January 5, 2026

First Covenant Church Lobby & Fellowship Addition – JGR Proj #25-3518

ADDENDUM NO. 2

A4.3

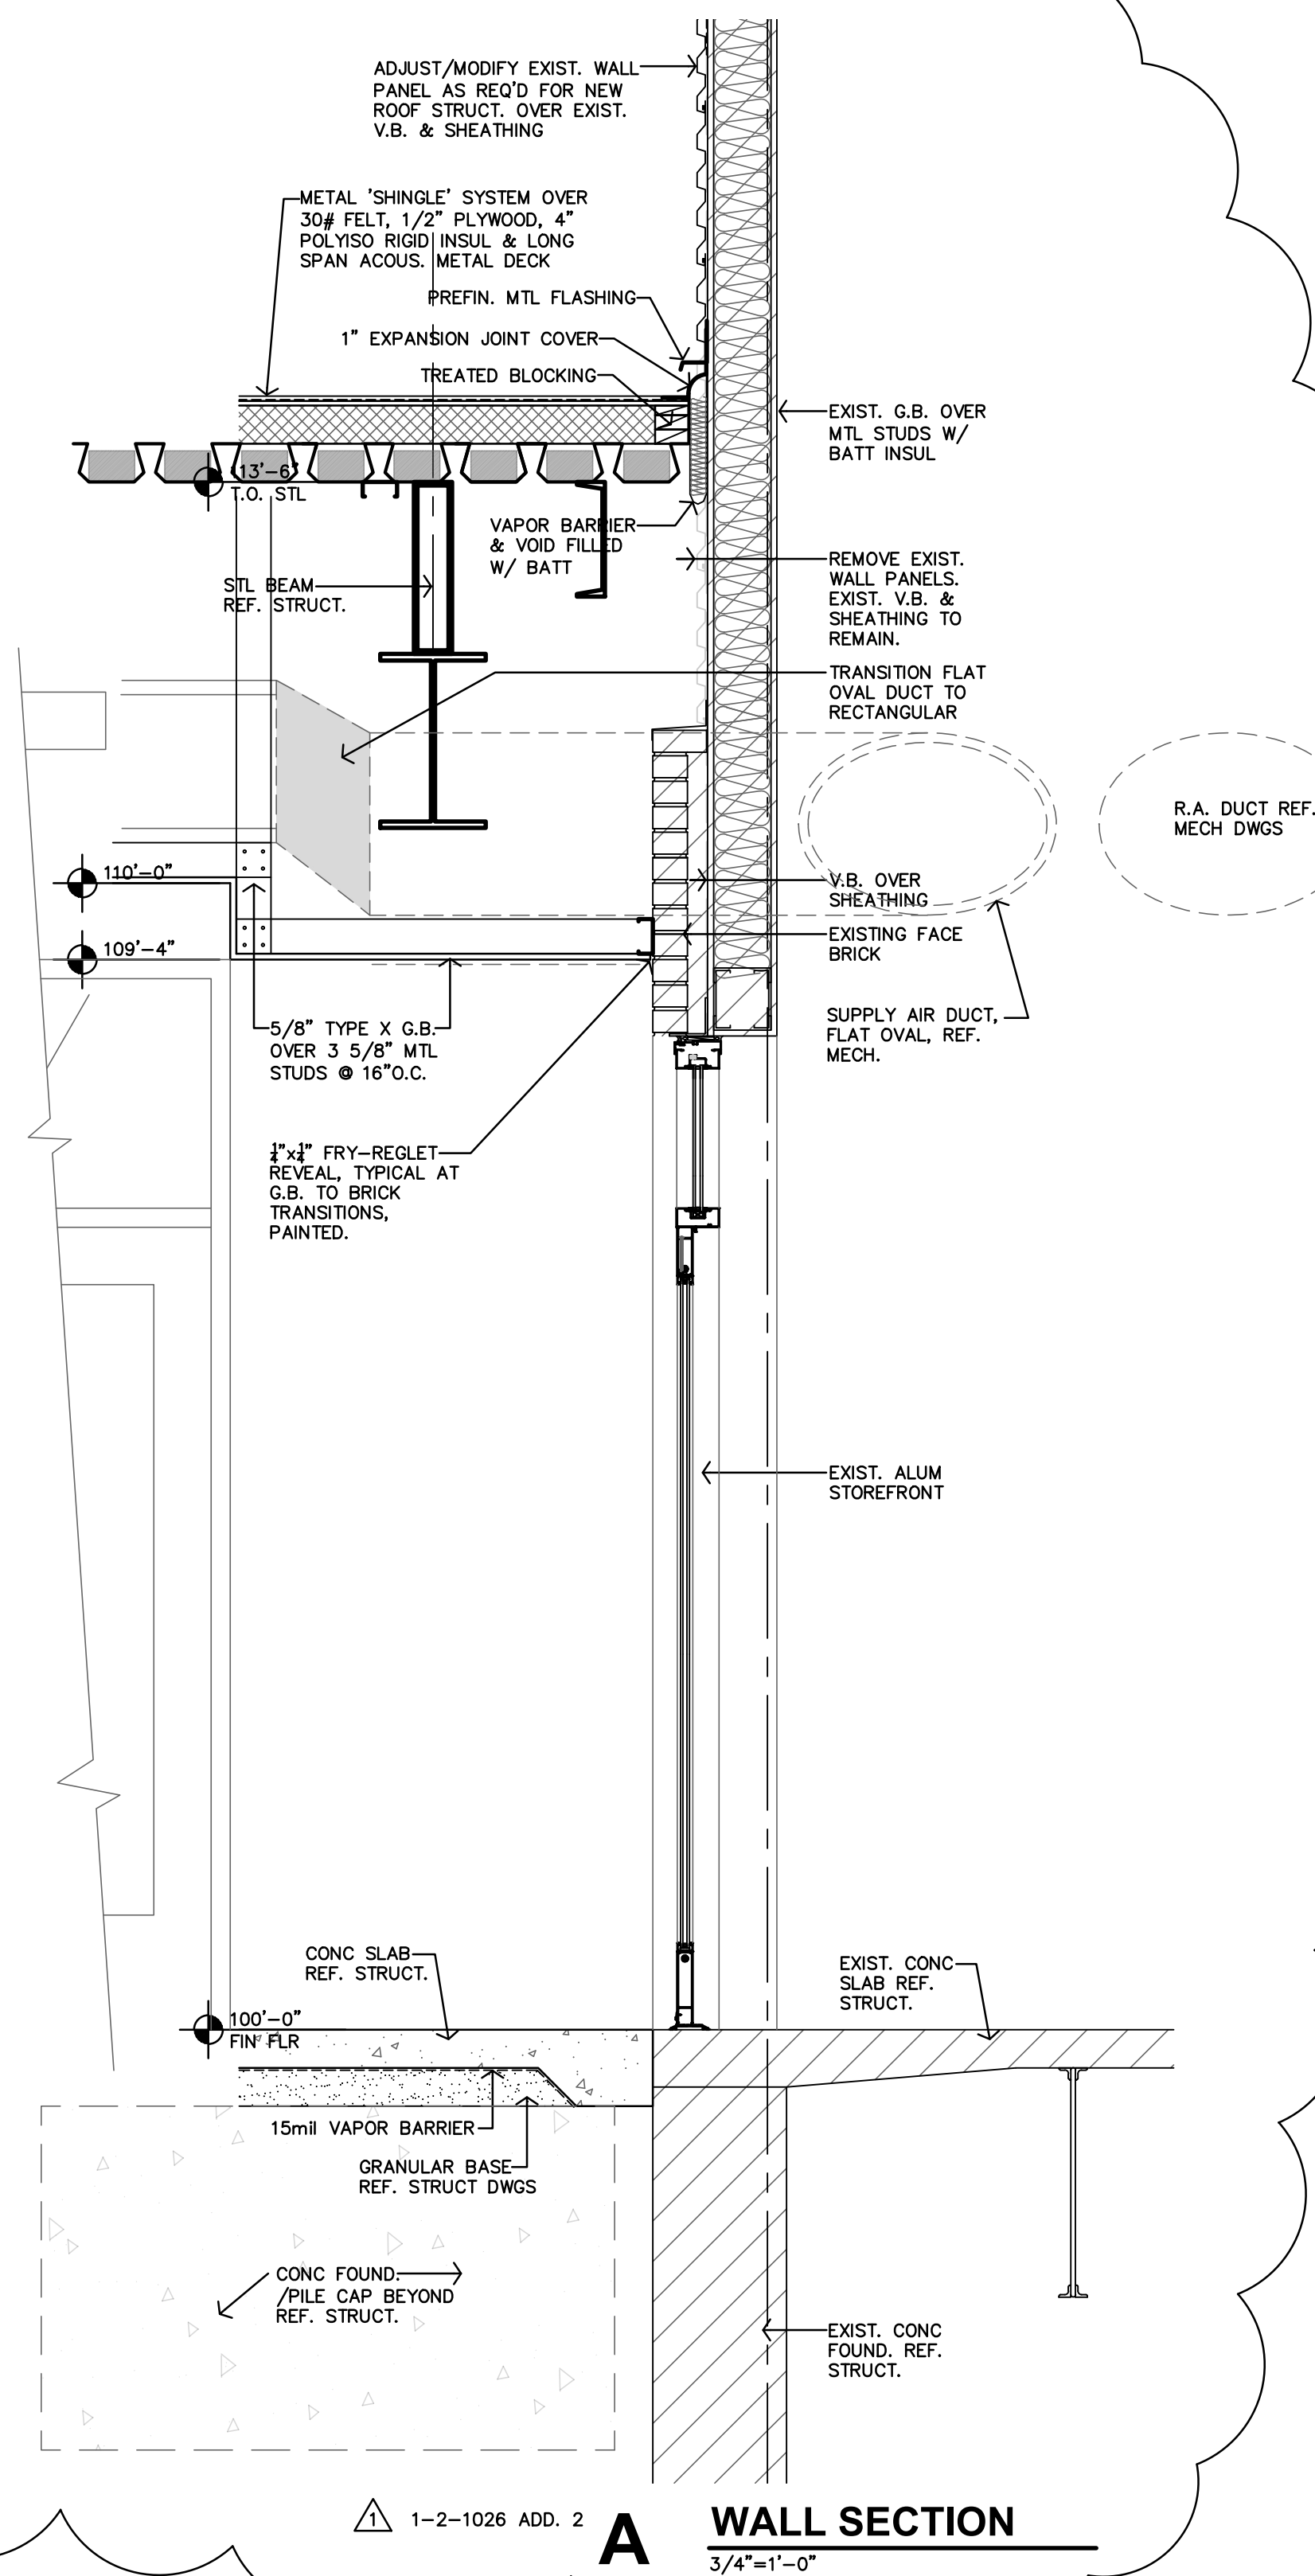
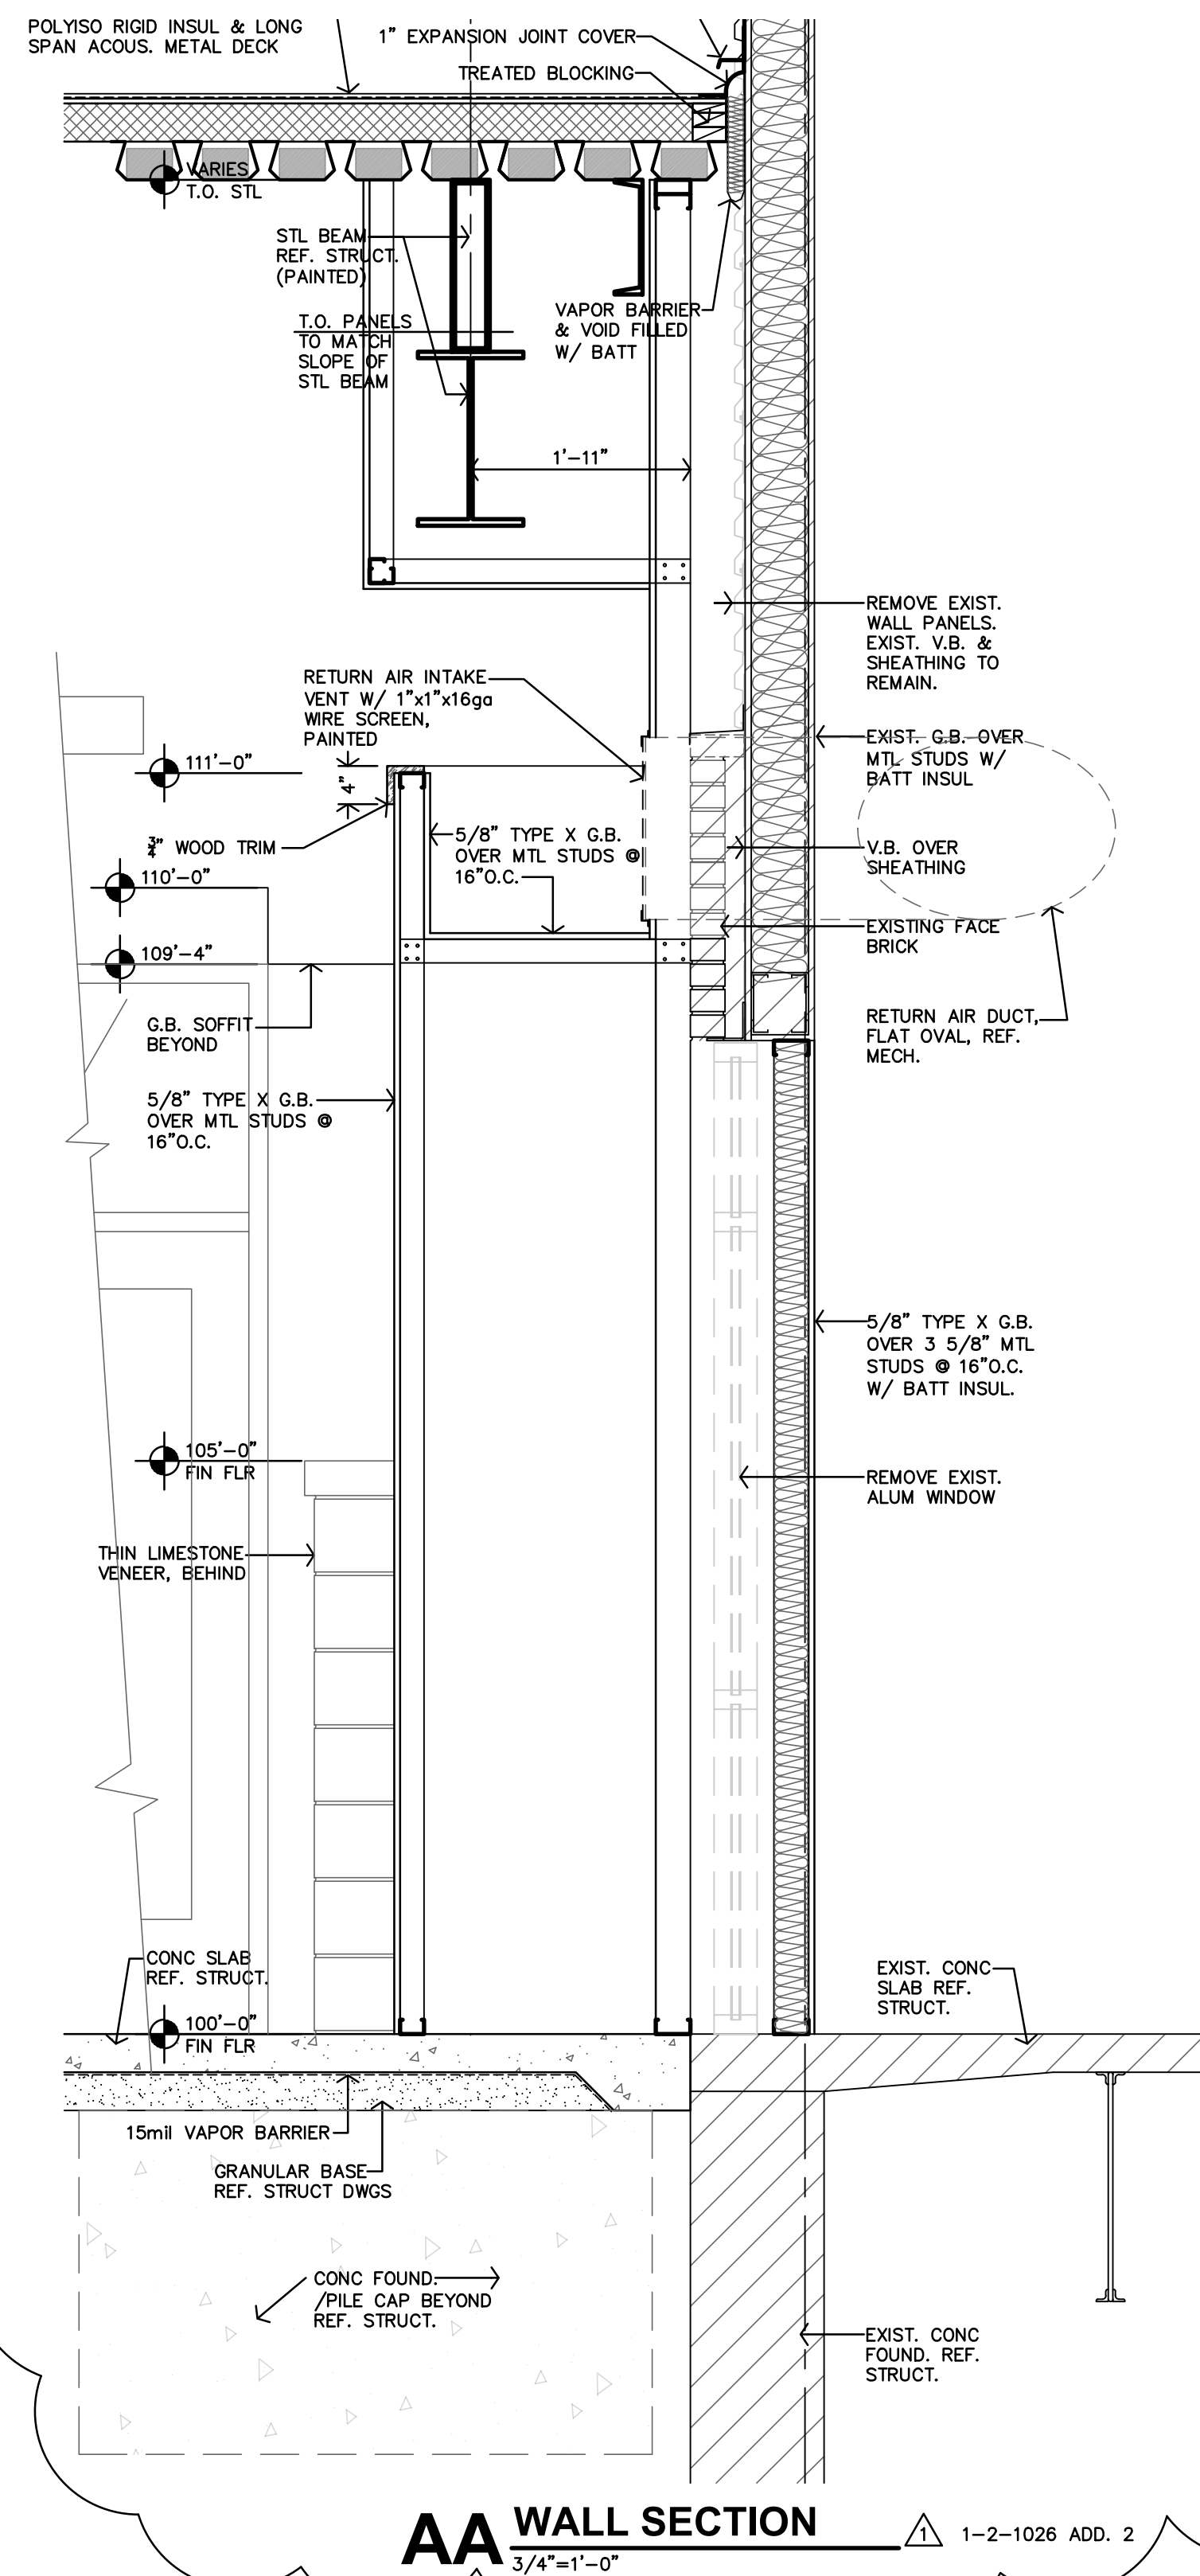
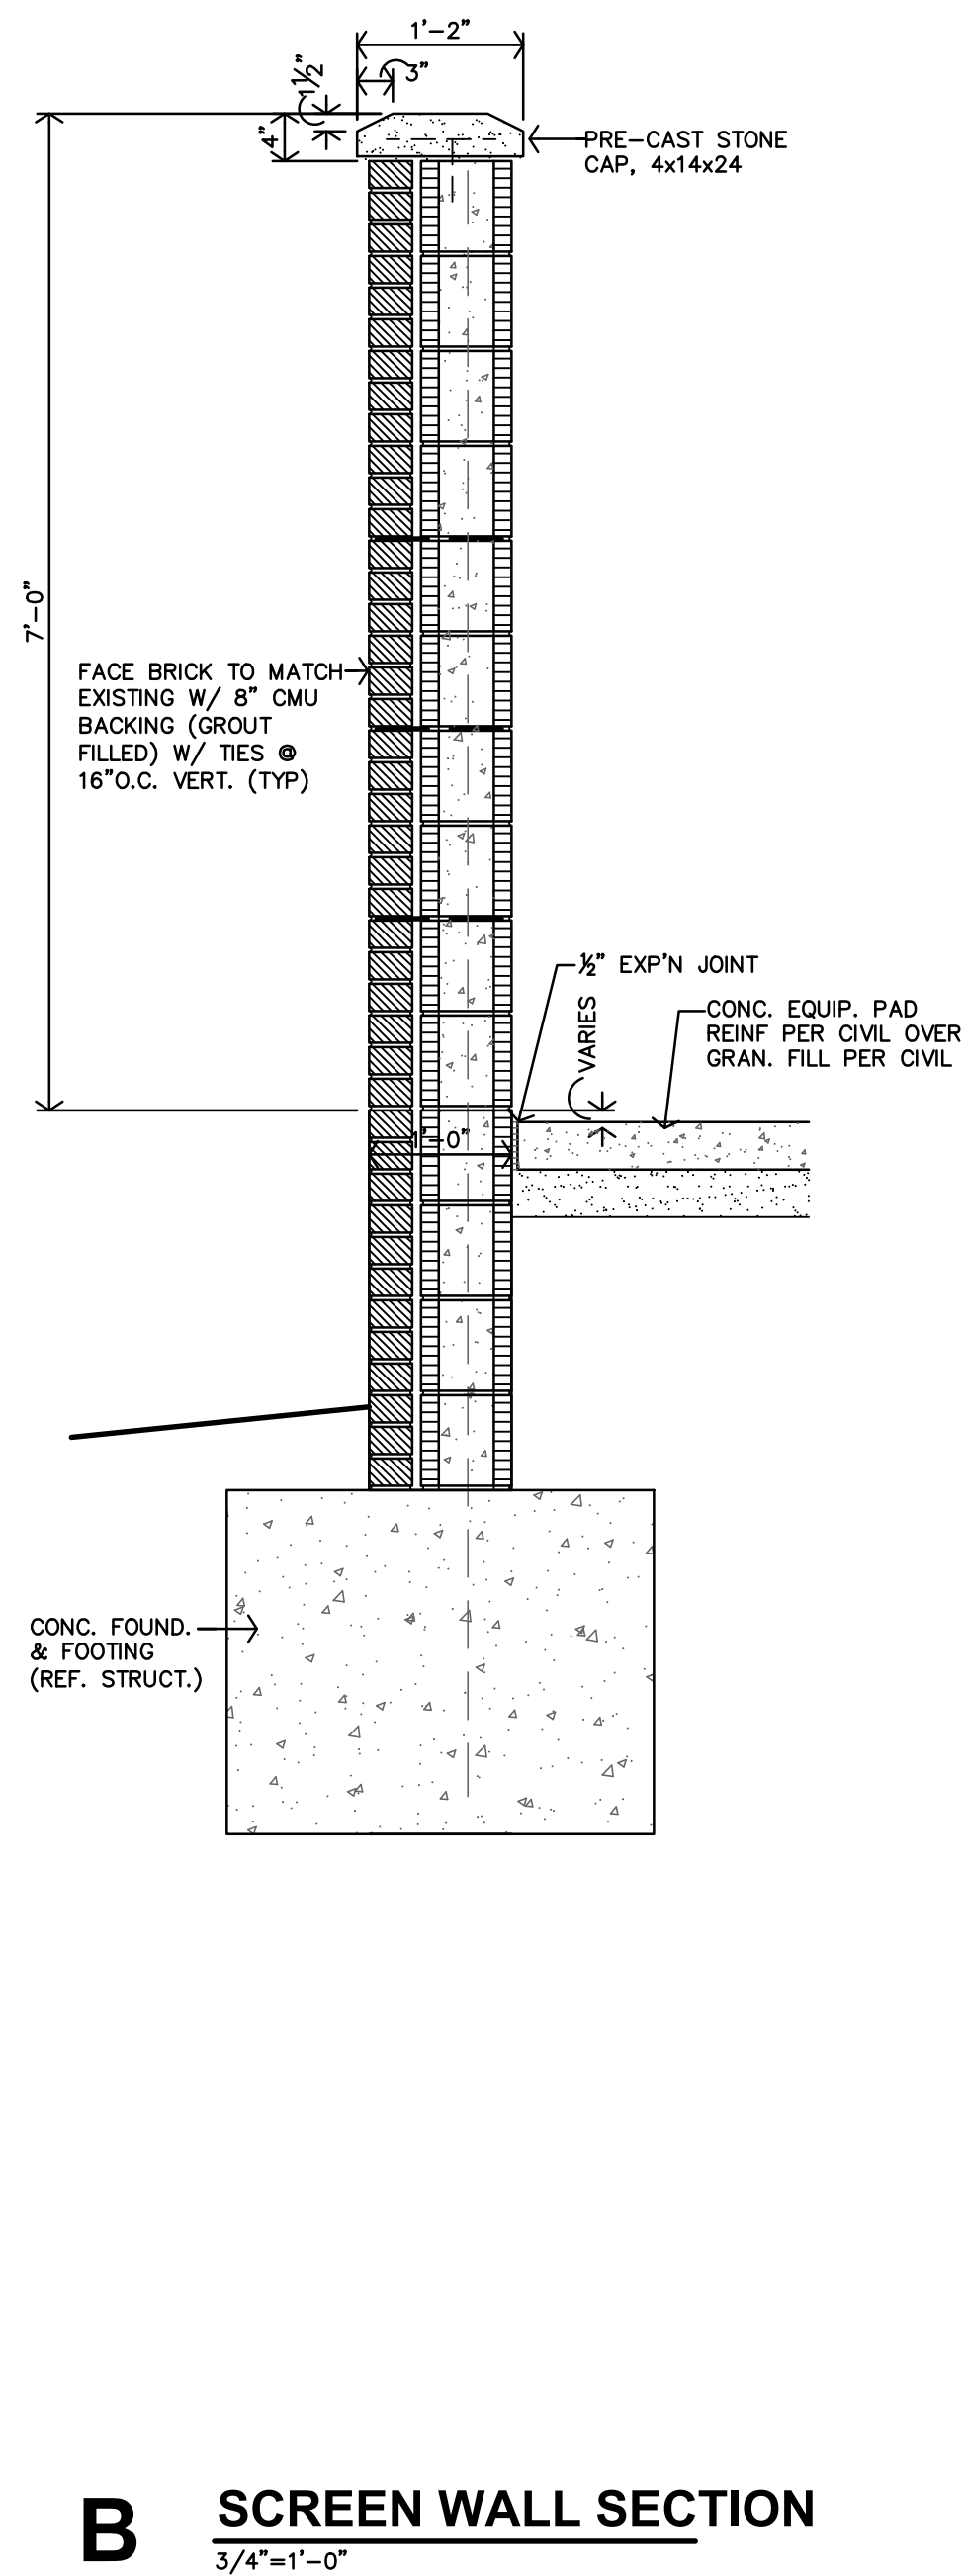
4. Sheet A4.3 – Wall Section A and Section AA (new) – Reference revised drawing sheet attached with this addendum for clarification regarding ductwork penetration and transition at the NW corner wall penetration.

5. Sheet A4.3 – Building Section D – Reference revised drawing sheet attached with this addendum for clarification regarding the masonry wall/retaining wall at the west side of the building. Brick and CMU shall extend down to the footing as shown on structural drawings.
